Addendum #4

RFP #2020-1222

GENERAL CONTRACTOR FOR THE WALTER I. M. HODGE DEVELOPMENT
ST. CROIX, U. S. VIRGIN ISLANDS

ADDENDUM #4

**BUILDING TYPE A
PLUMBING PLAN**

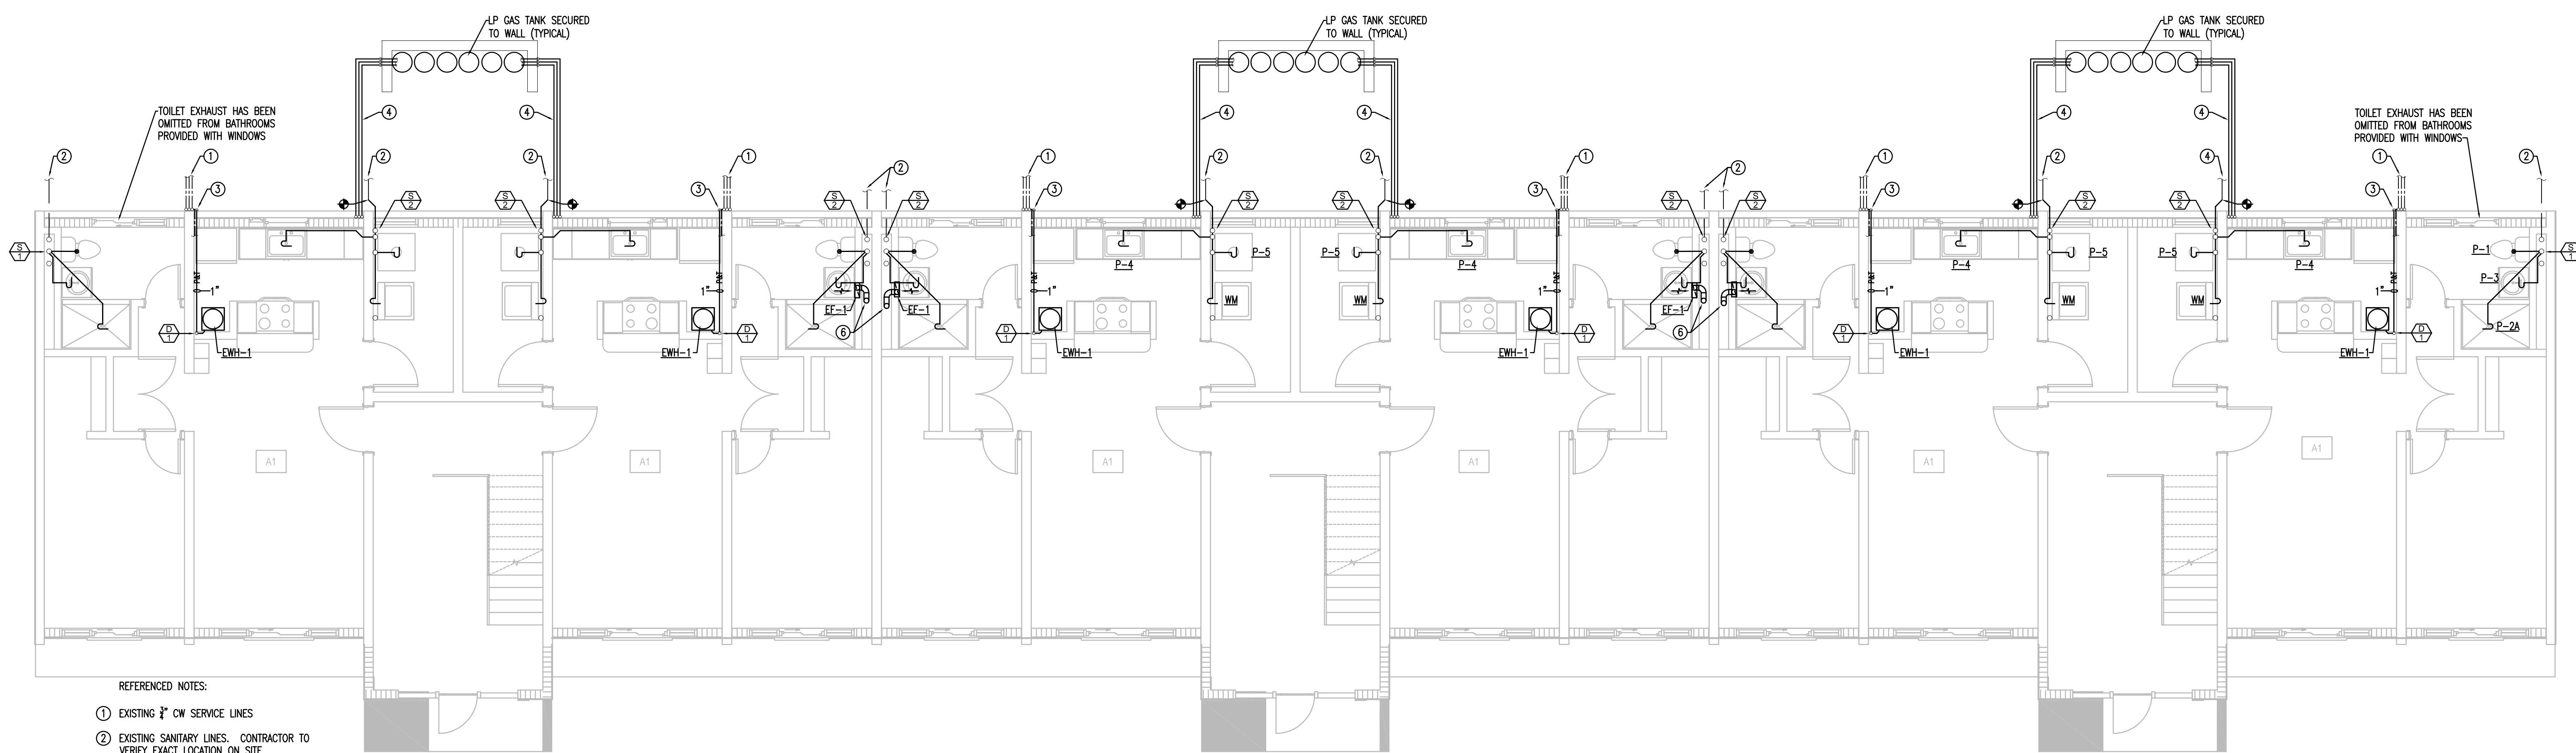
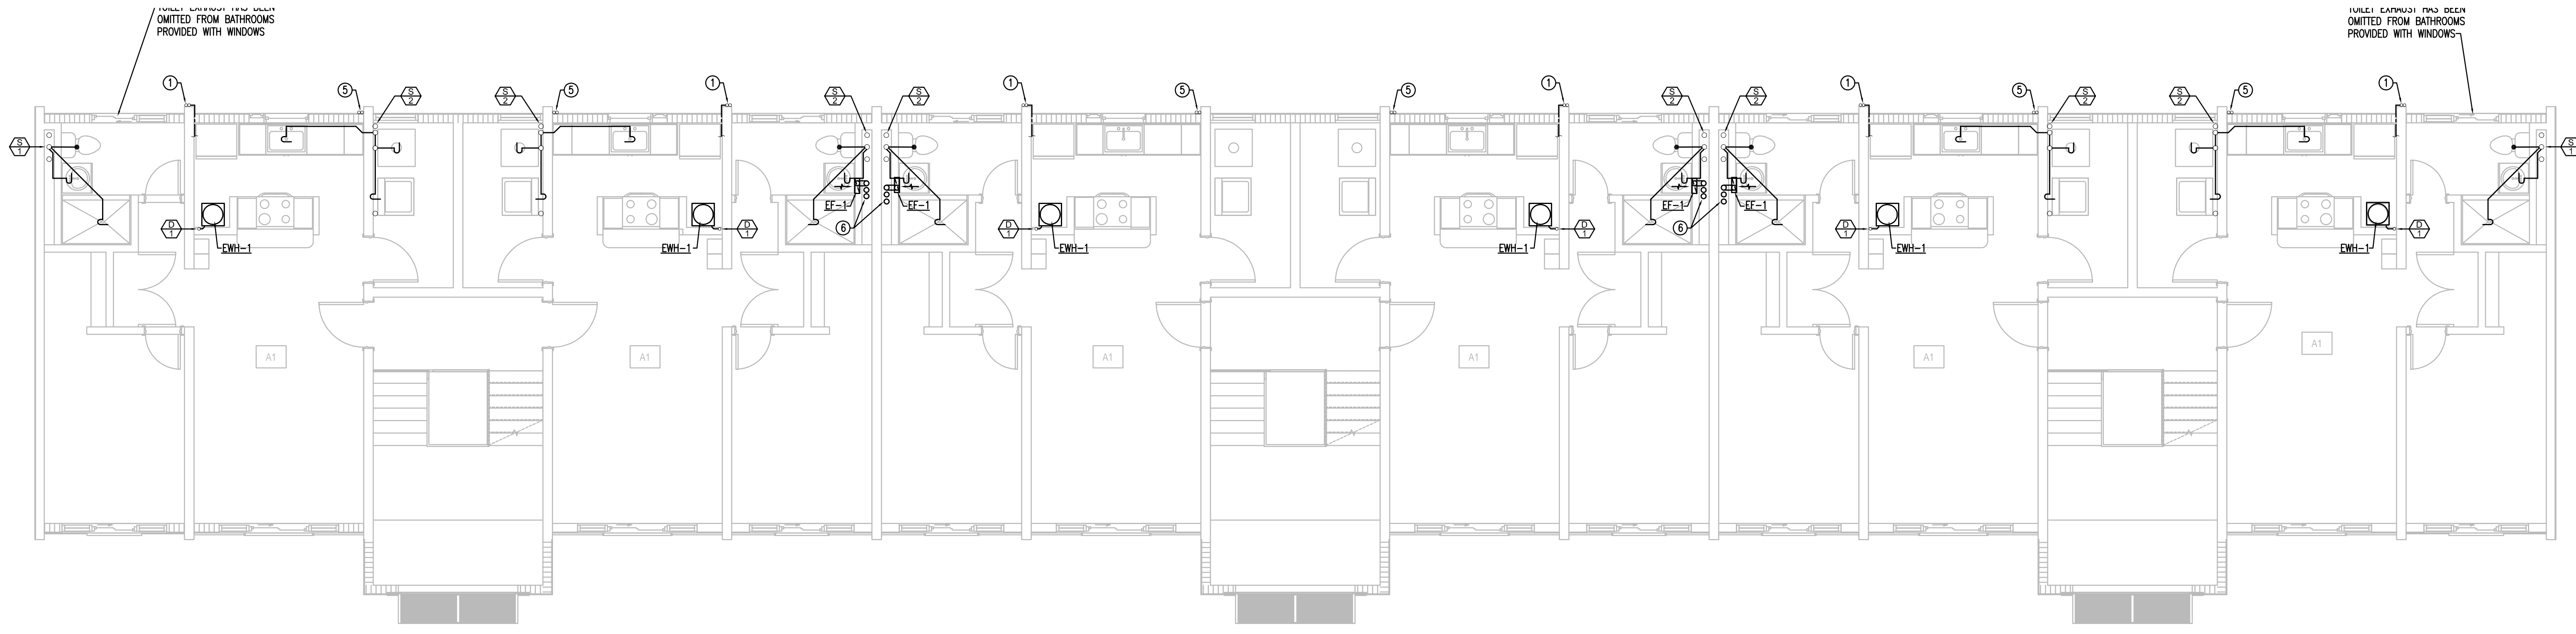
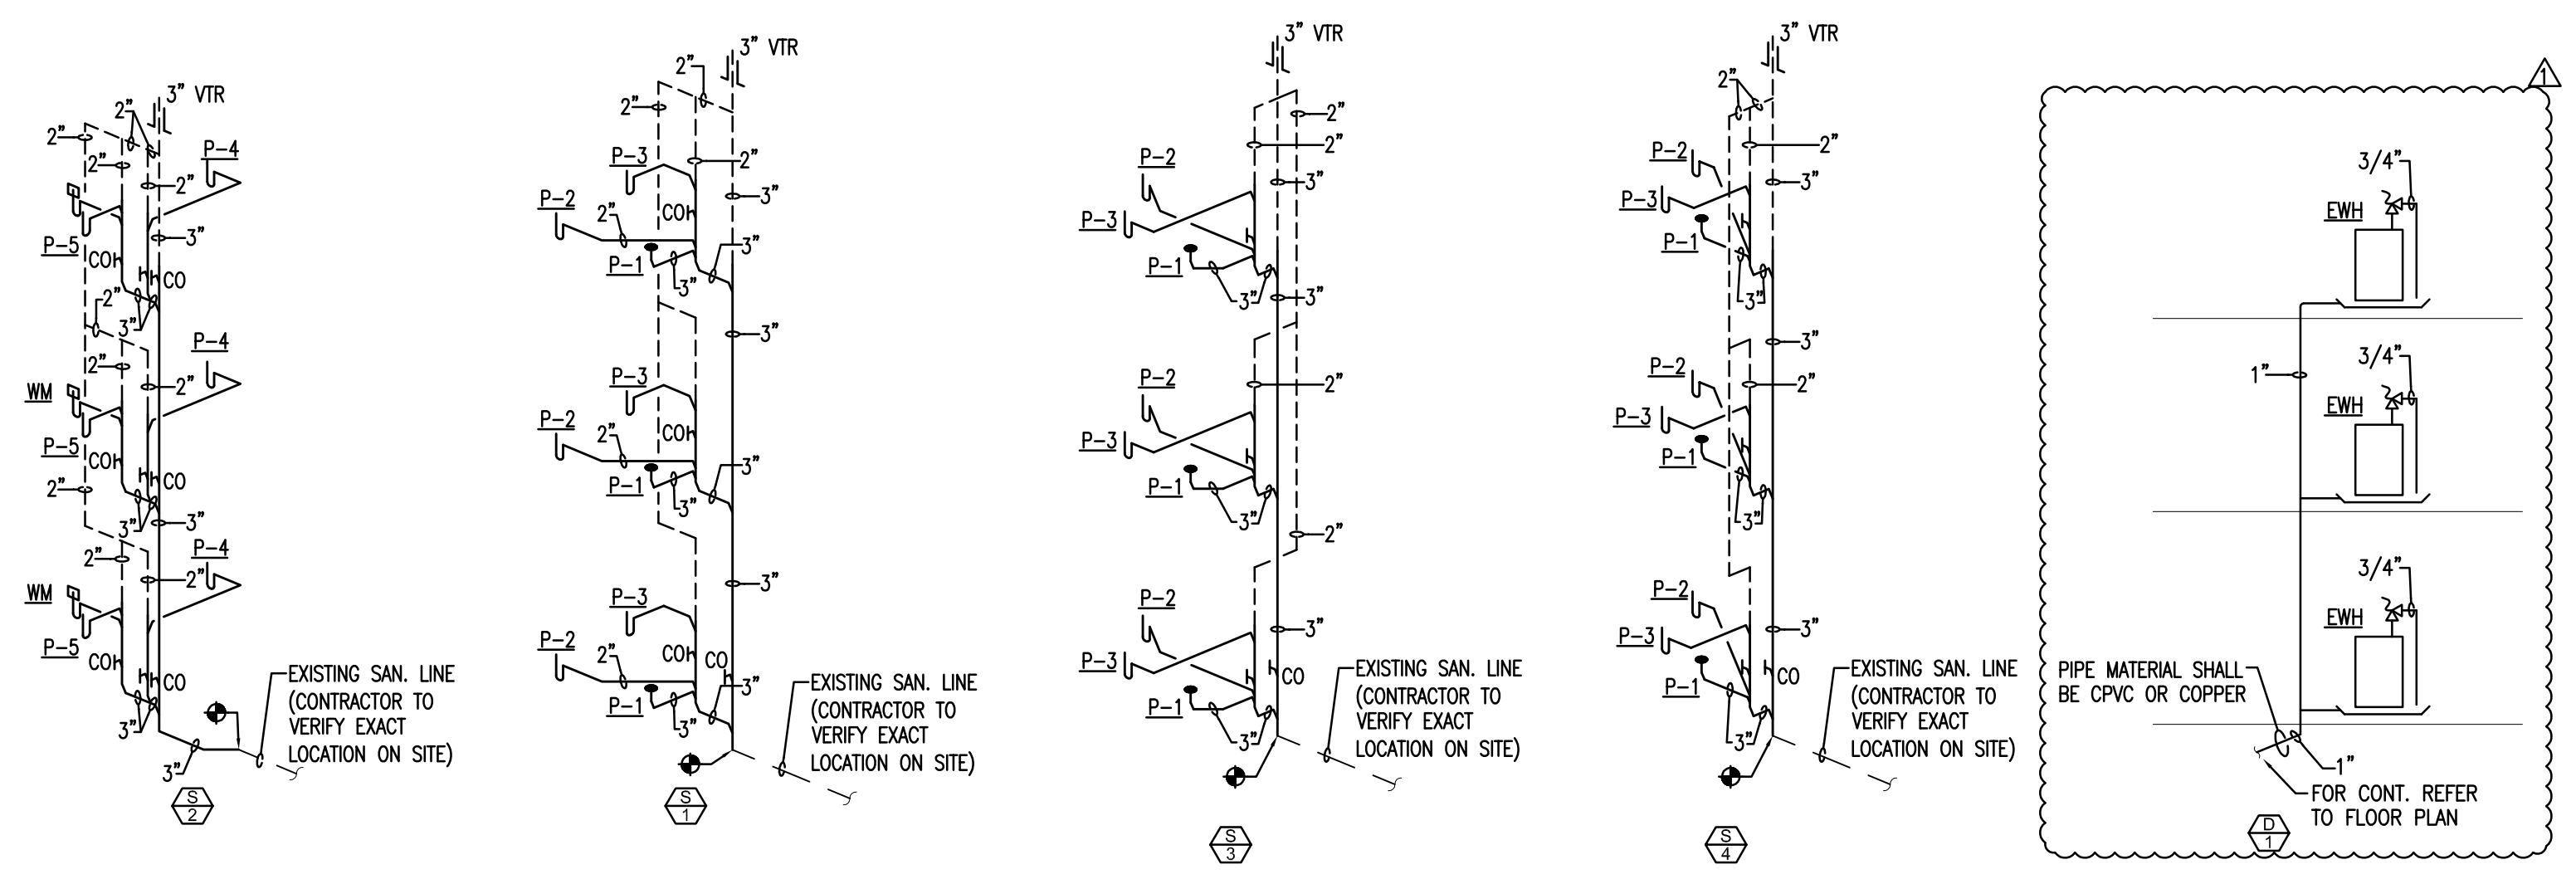
“There is a tag (S/1) & (D/1) for riser on page P-2.0 of plumbing drawings. But the riser detail for tag (D/1) is not given.”

Clarification: Riser D/1 has been added on P-2.0.
